**REVISED TECHNICAL SPECIFICATIONS
AND TECHNICAL SPECIFICATION BASES PAGES**

REVISED UFSAR

UFSAR CHANGE DFL 97011
SHORT-TERM/LONG-TERM CONTAINMENT PRESSURE AND TEMP

Figure 6.2-19a - Short Term Suppression Pool Temperature Response - Case 6a2 - 60% Mixing Efficiency

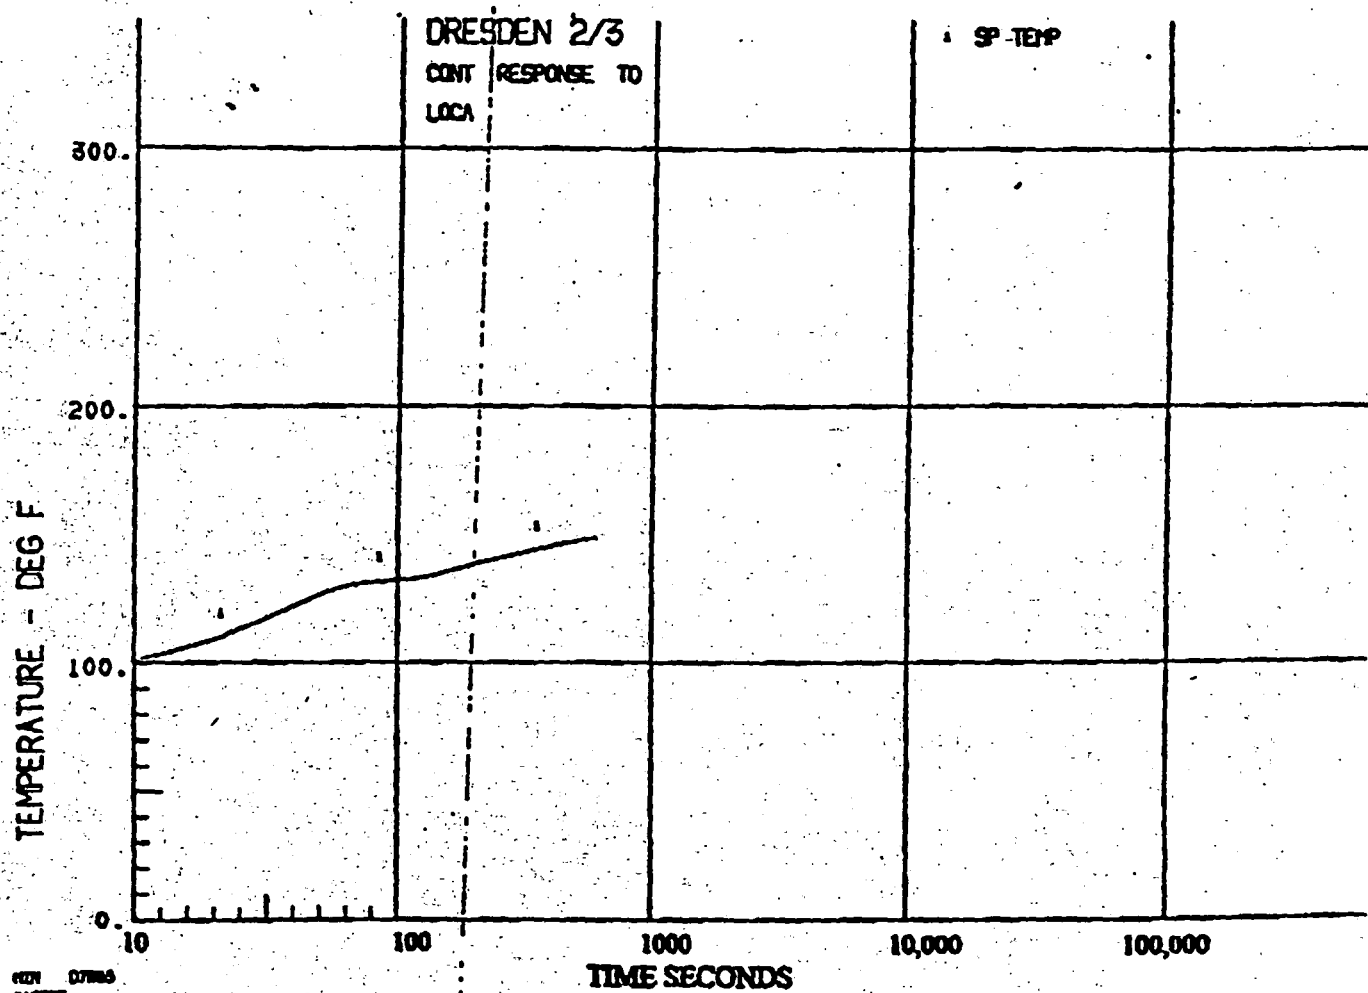
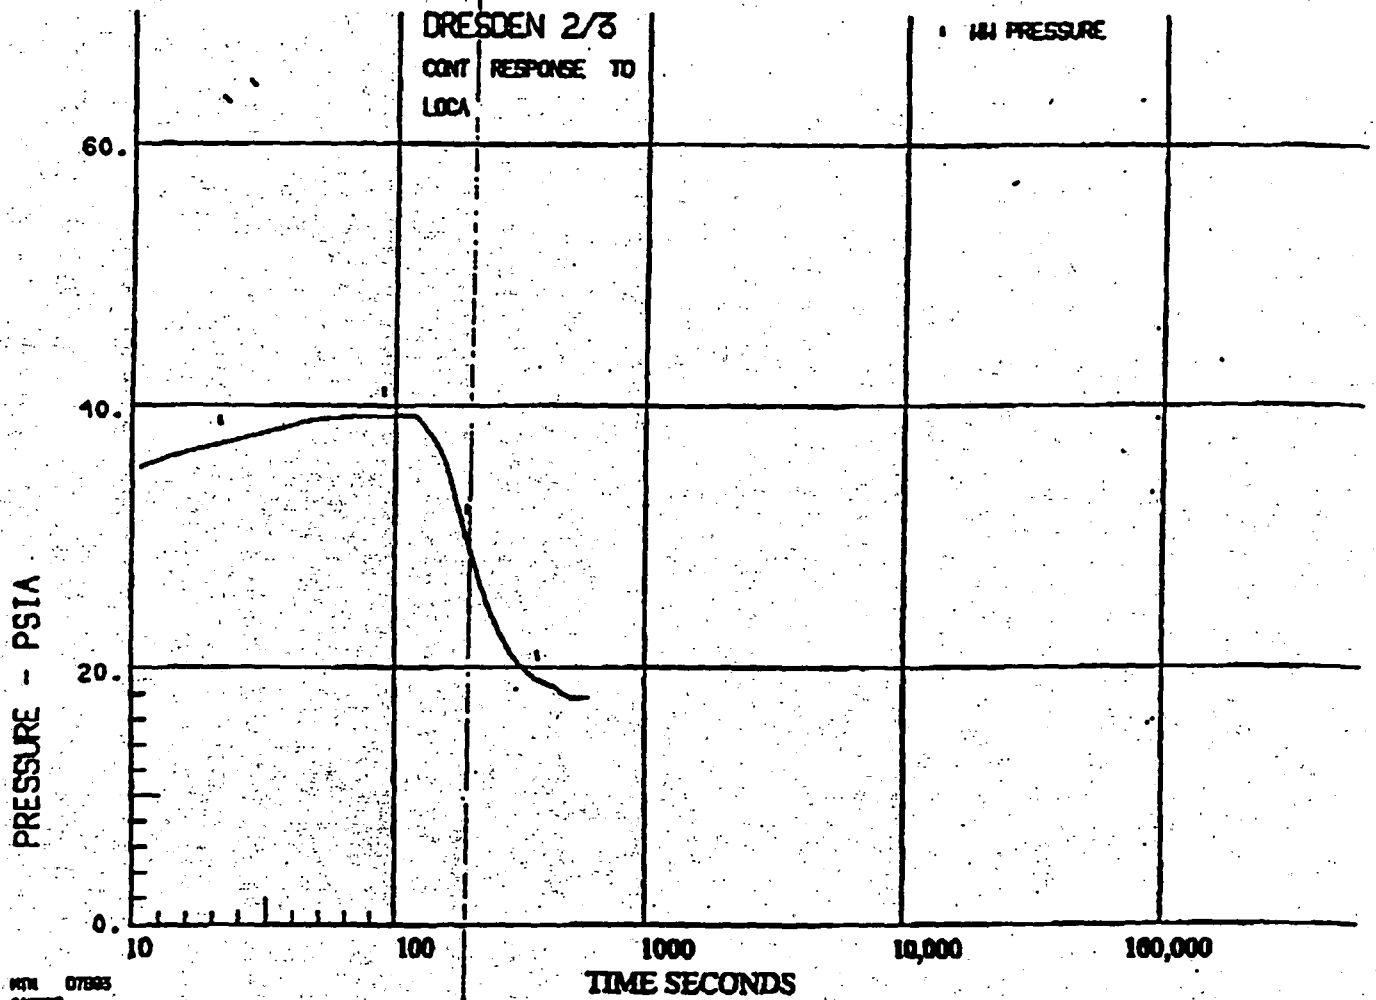
3	6.2.1.3.2.2 (new)	N/A	6.2-24	Added new subsection which covers the new evaluation for the containment short term response to a design bases accident (DBA) LOCA for minimum NPSH available. The discussion covers the worse case condition for the first 600 seconds of the accident. This change is a result of the Licensing Amendment to reevaluate LPCI and Core Spray pump requirements.
3	6.2.1.3.3	1,3 to 8	6.2-25	Renumbered subsection to 6.2.1.3.2.3 to maintain consistency in the LOCA discussion. Included statement that LPCI and core spray will help remove the noncondensable gases during the first 10 minutes (paragraph 1). In paragraphs 3 through 8, references to the original licensing basis for long term cooling were removed to reflect the current licensing basis being initiated for the long term DBA-LOCA. This current basis reflects the worse case condition for LPCI and core spray operation and its acceptability. This change is a result of the Licensing Amendment to reevaluate LPCI and Core Spray pump requirements.

ADD FIG. 6.2-19a & -19b From attached insert

Figure 6.2-20a - Long Term Suppression Pool Temperature Response. Case 2a1 - High (100%) Mixing Efficiency

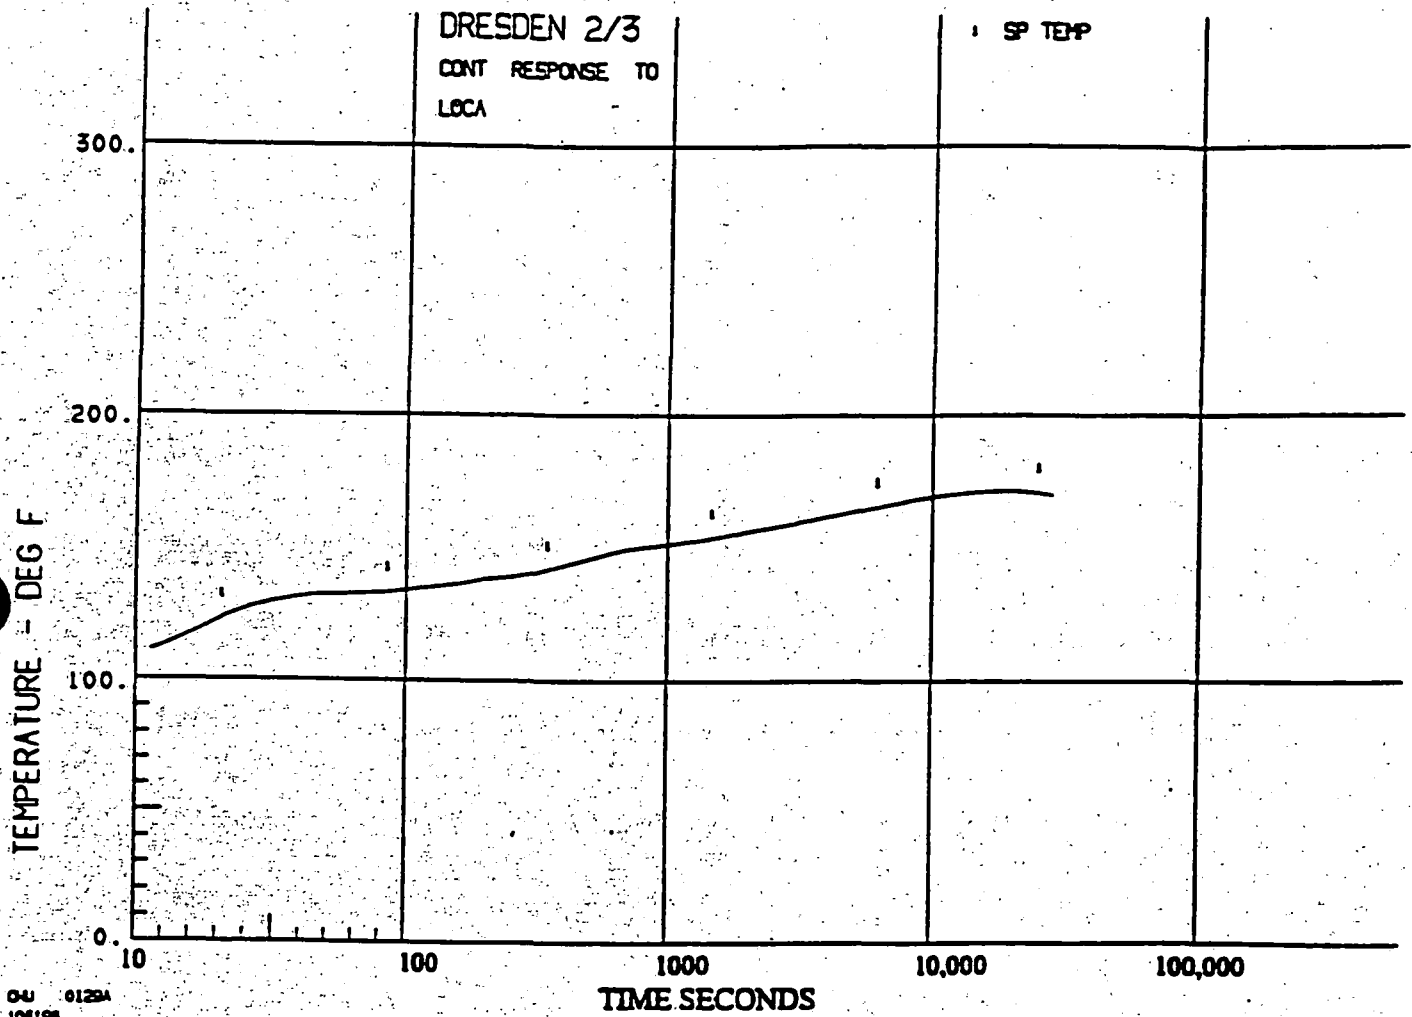
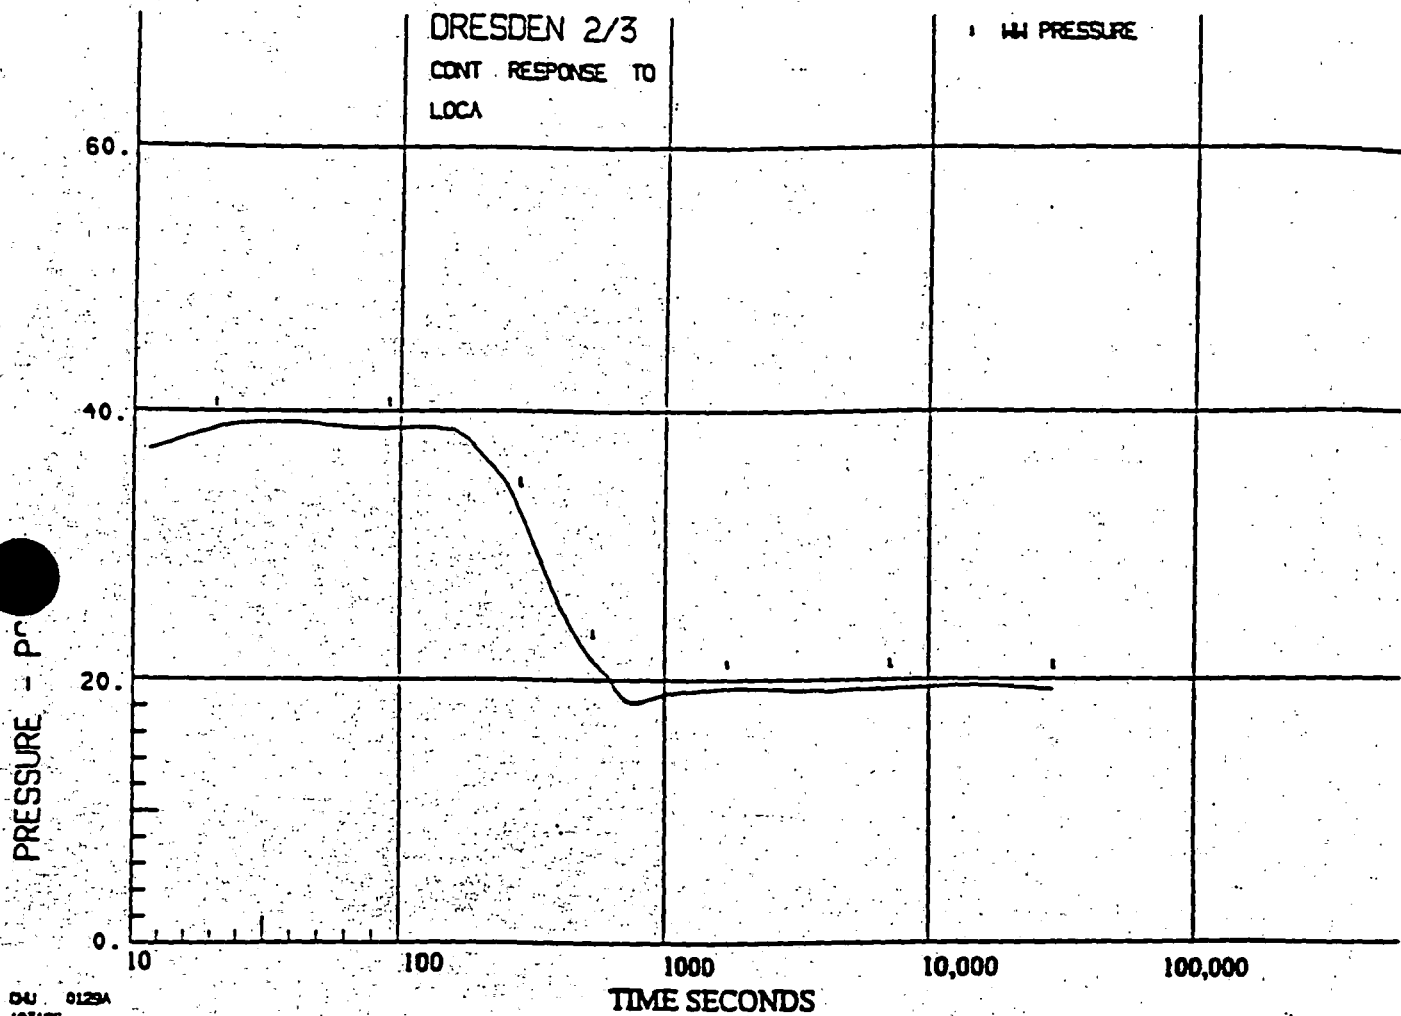
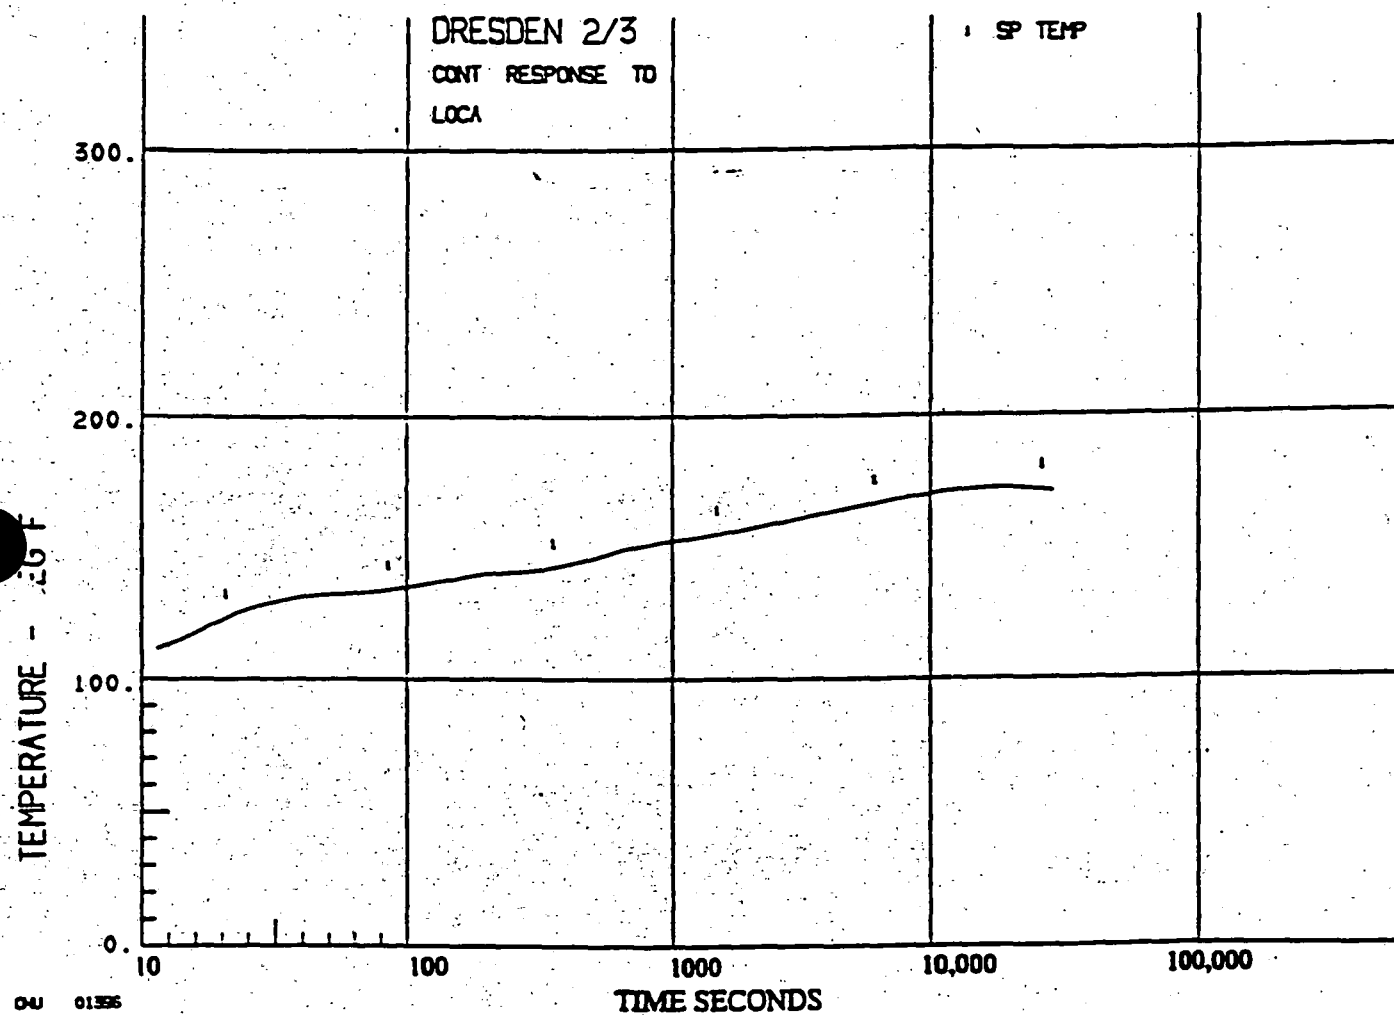
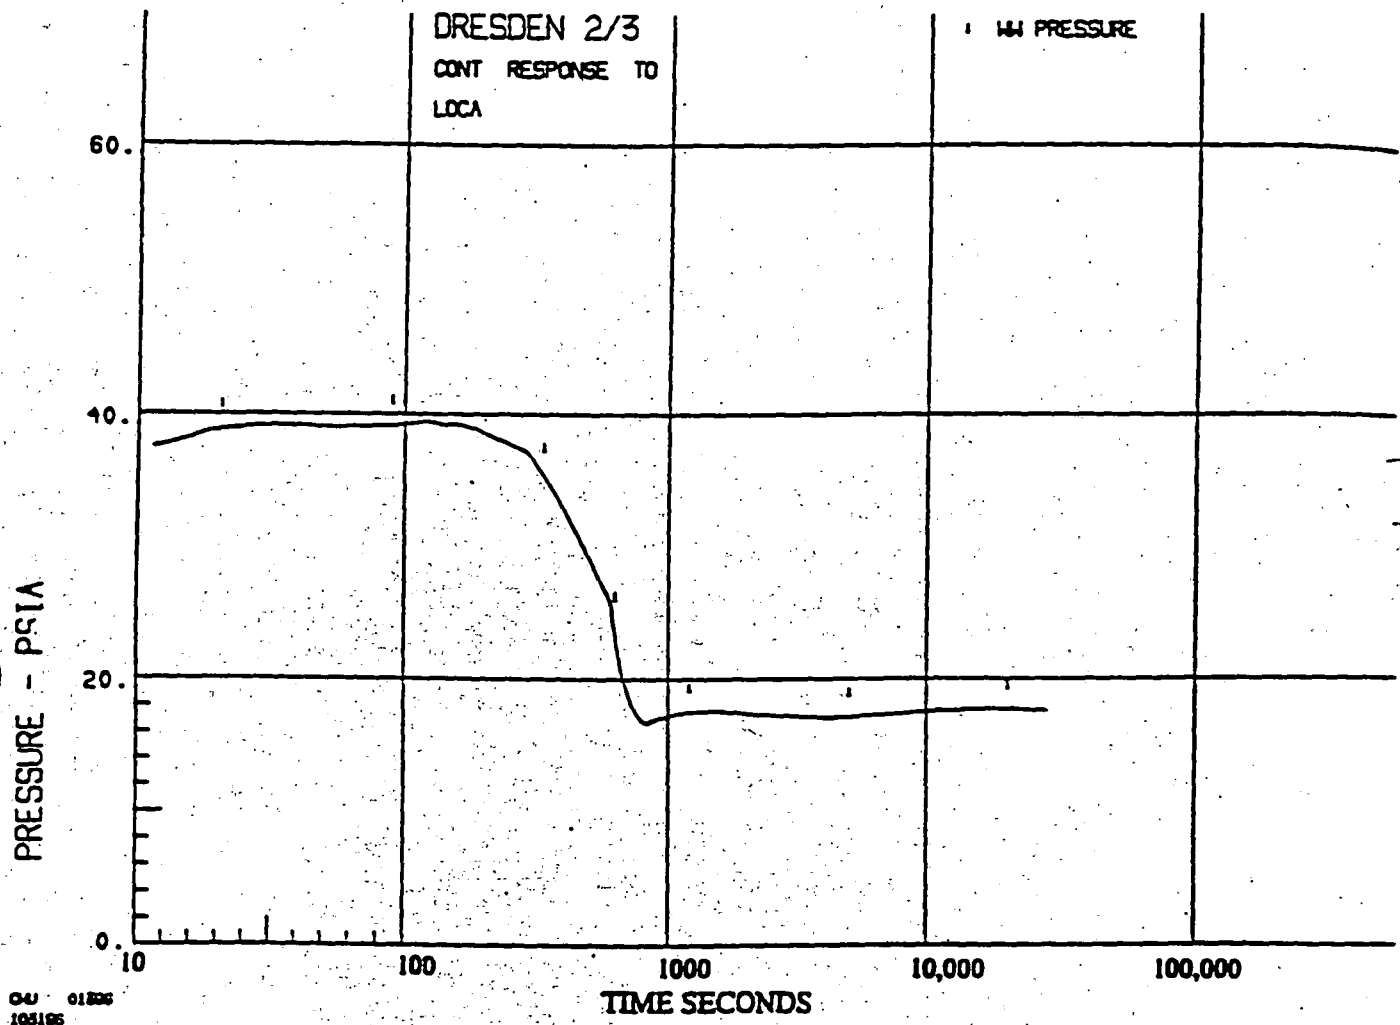
ADD FIG. 6.2-20a, 20b, 20c, 20d From attached insert
6-v

FIGURE 6.3-80

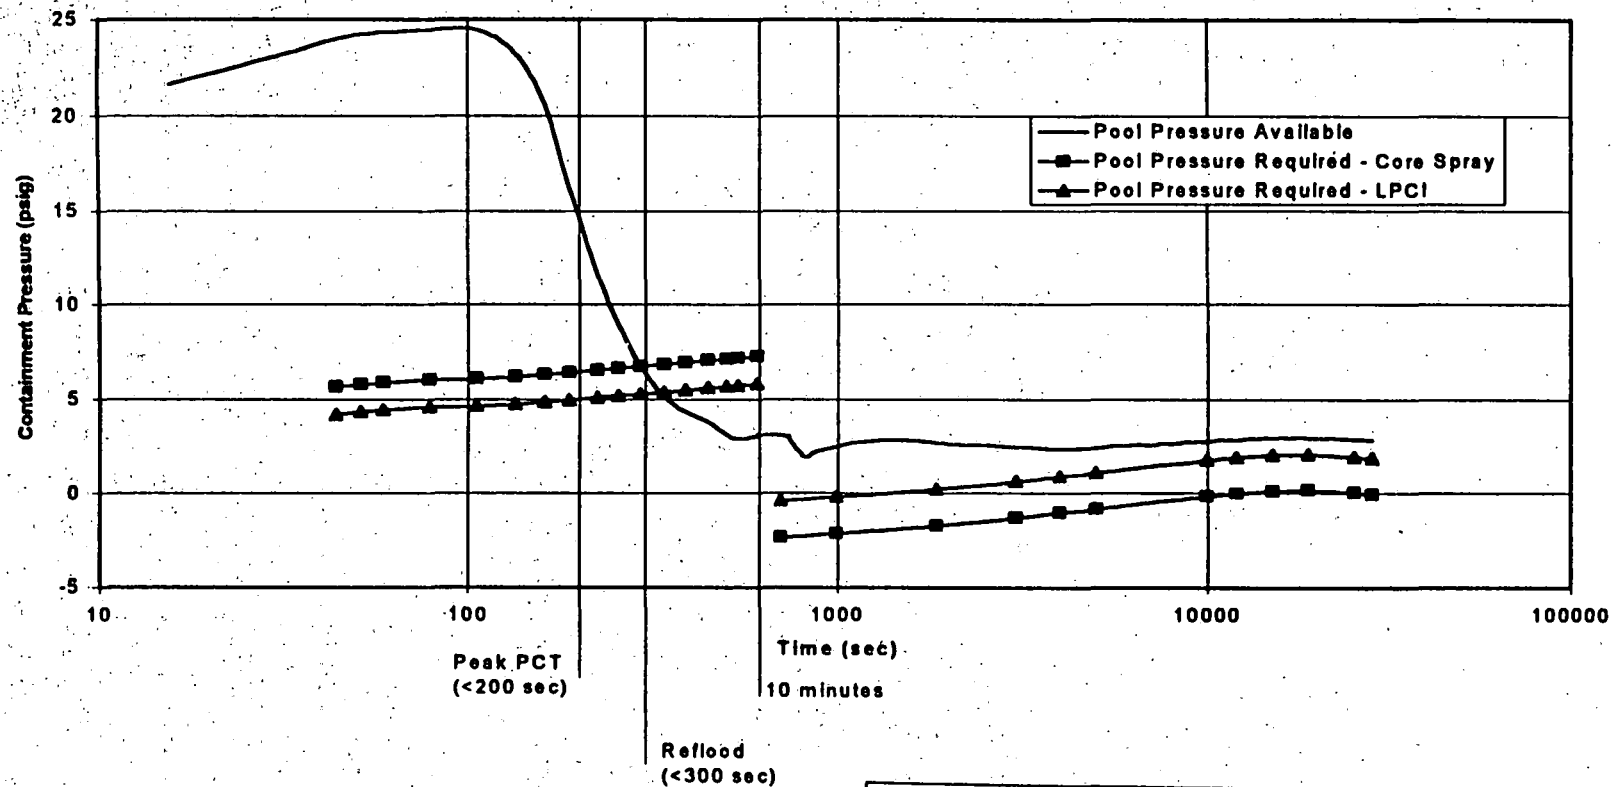
REPLACE W/
NEW FIGURE
6.3-80

Figure 6.3-80 gives a graphical representation of the minimum required containment pressure to meet NPSH requirements for both LPCI and Core Spray pumps. The chart covers both the short-term (≤ 600 seconds) and long-term (> 600 seconds) periods.
